City of Sunset Valley

3205 Jones Road

**Modification of a Previously
Approved Water Pollution
Abatement Plan Application**

May, 2024

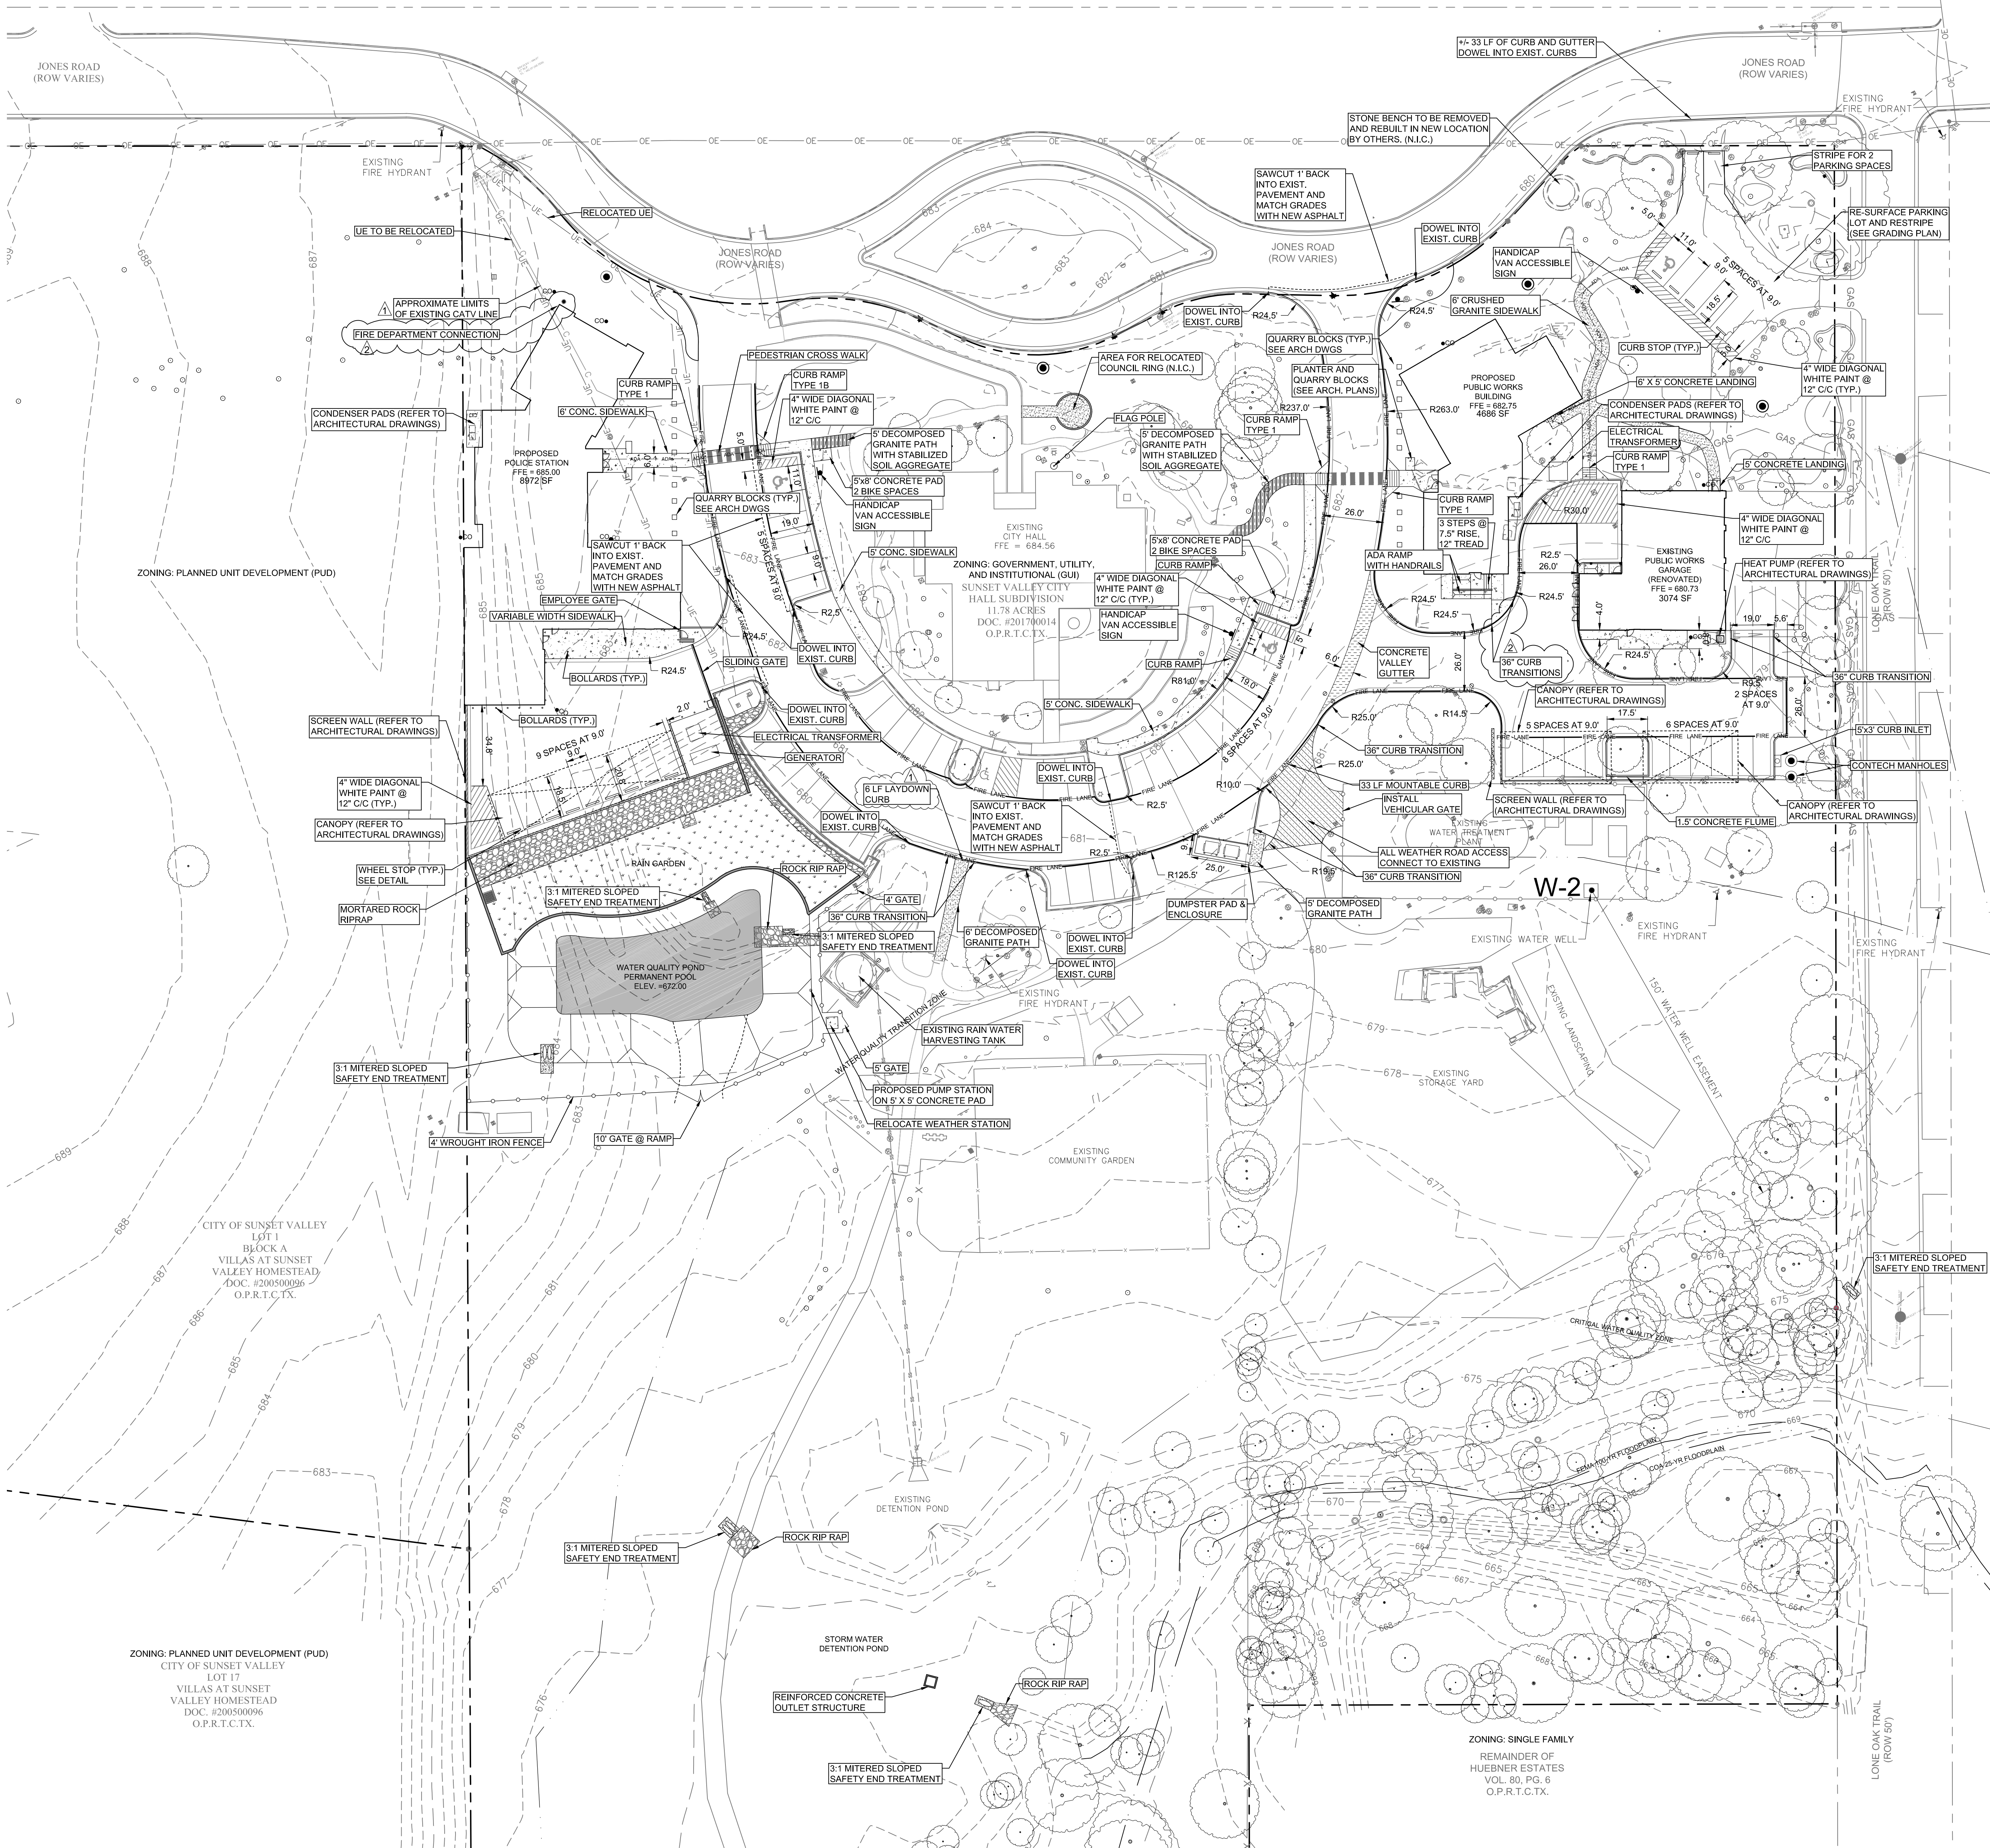
potential for mixing of water quality volume with the excess water collected above the provided WQV elevation. It should be noted, however, that the drainage runoff from all pavement area filters through the rain garden facility prior to entering the retention pond. All other drainage runoff entering directly to the retention pond is collected directly from the roofs of buildings. The rain garden facility was not formally approved as a permanent best management practice by TCEQ but is mentioned within the approval letter from TCEQ as a pre-treatment facility.

This WPAP Modification is submitted to request the approval of the adjusted provided WQV and the adjusted provided WQV elevation. The required WQV remains at 5,624 cubic feet at elevation 673.33 ft-msl. The provided WQV of this permanent BMP is now 8,394 cubic feet at an elevation of 673.9 ft-msl. There is potential for some leakage of mixed water from the retention pond above this provided WQV elevation.

WATER QUALITY POND PLAN

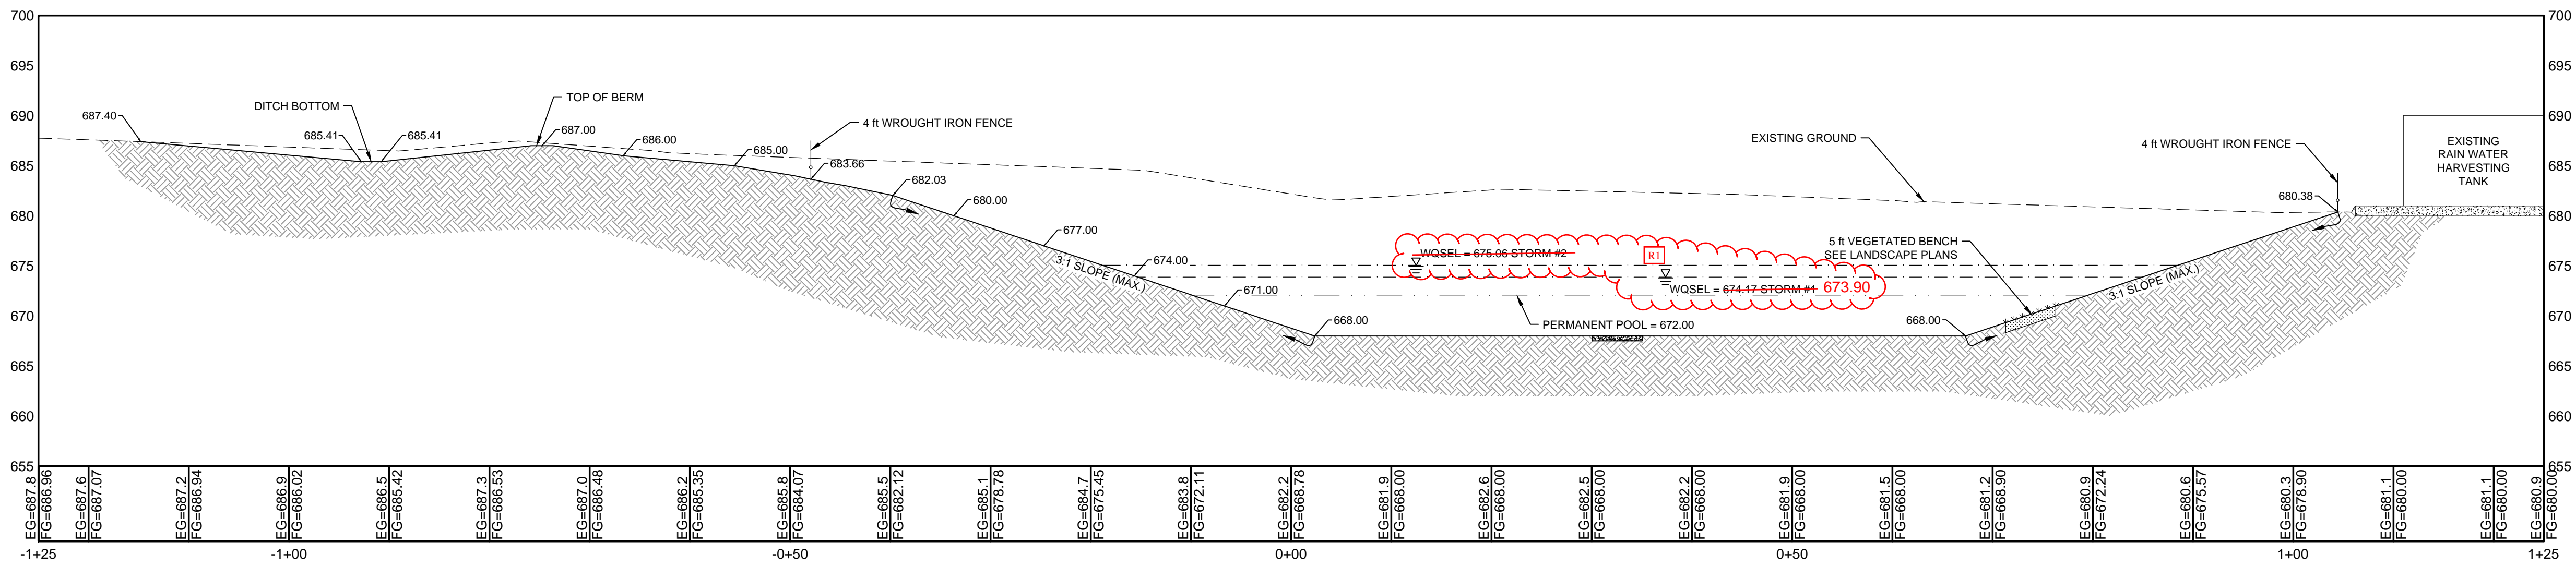
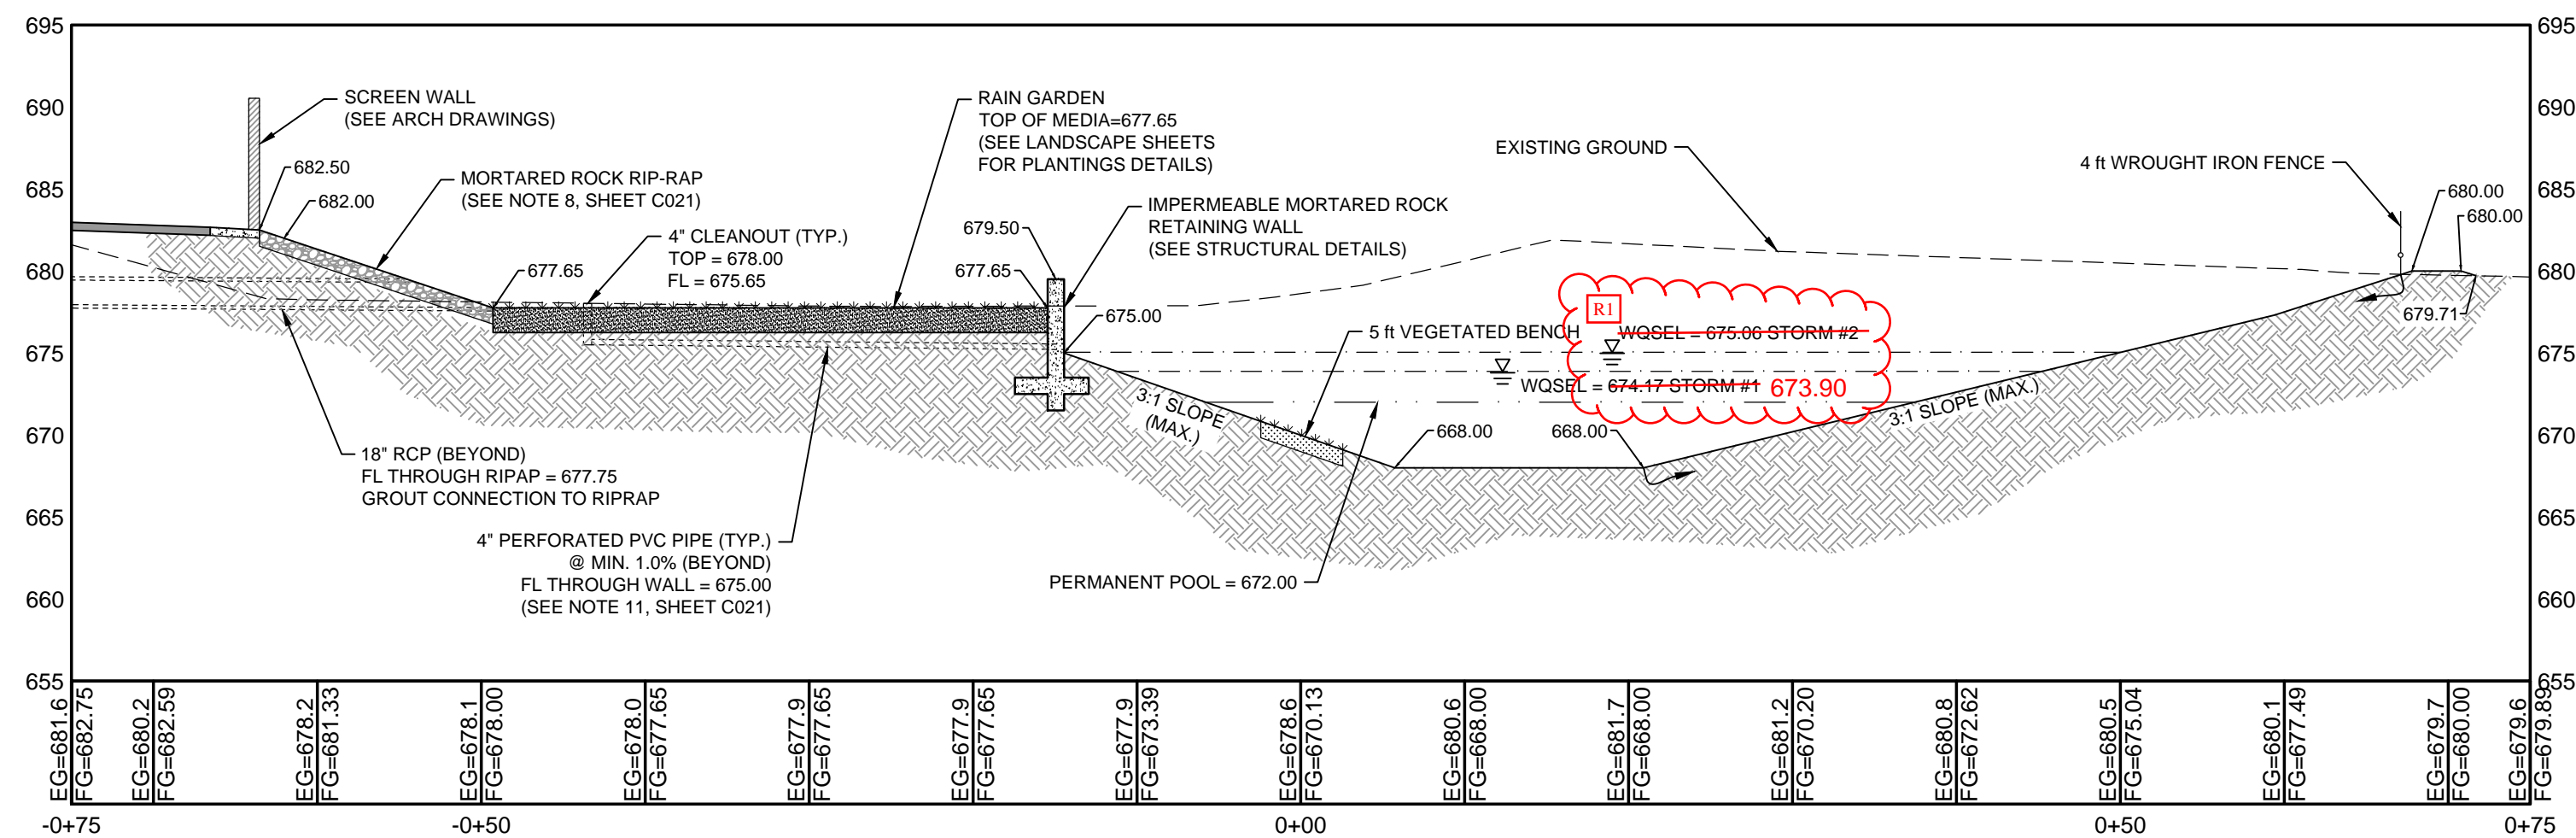
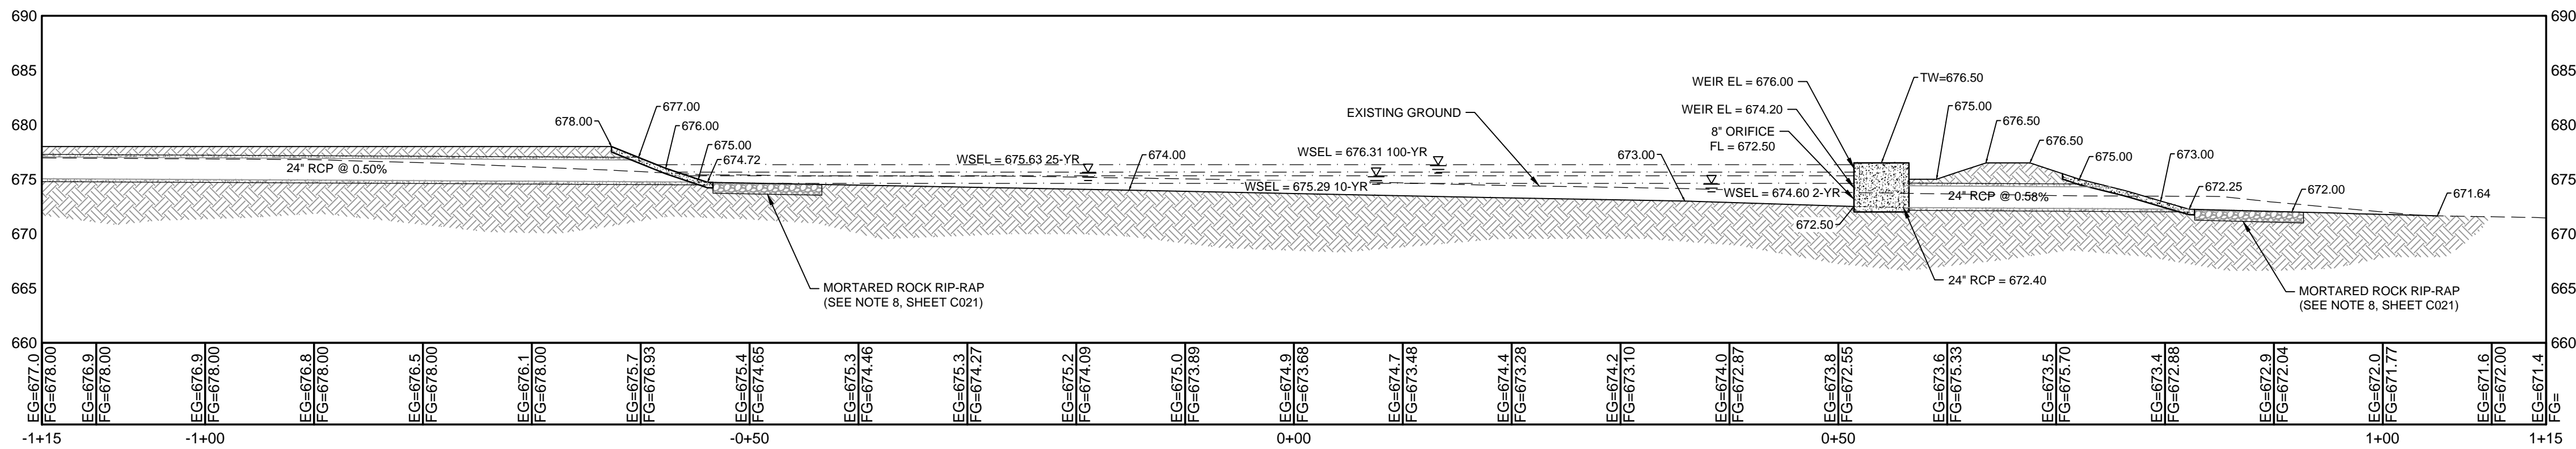
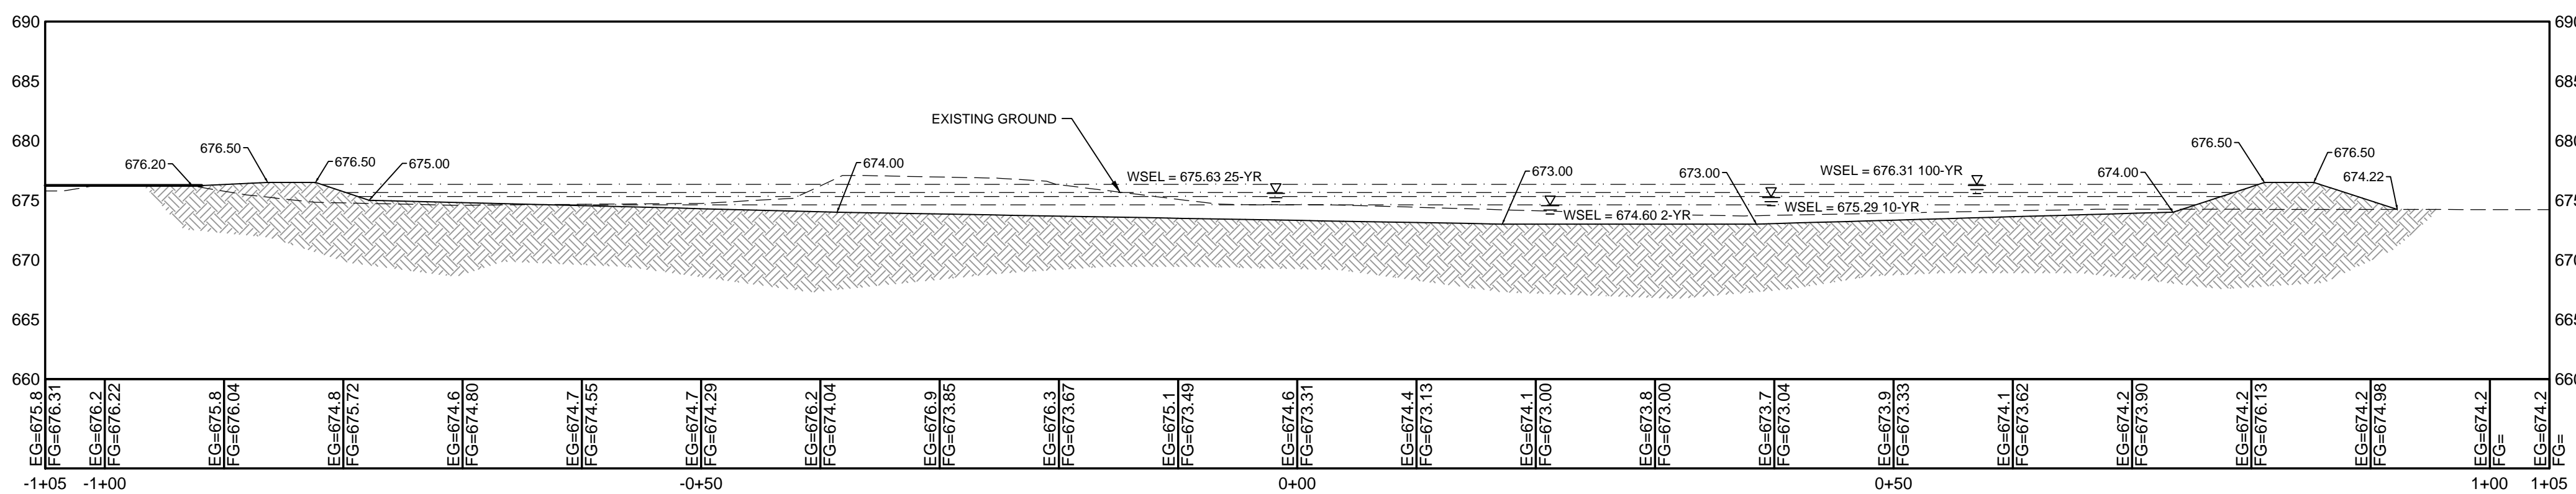
This current WPAP Modification is submitted to adjust the Water Quality Volume (WQV) elevations and the provided WQV, which exceeds the required WQV. Additionally, more irrigation area has been proposed with this current WPAP Modification. See the *Modification to a Previously Approved Plan* application section for more information.
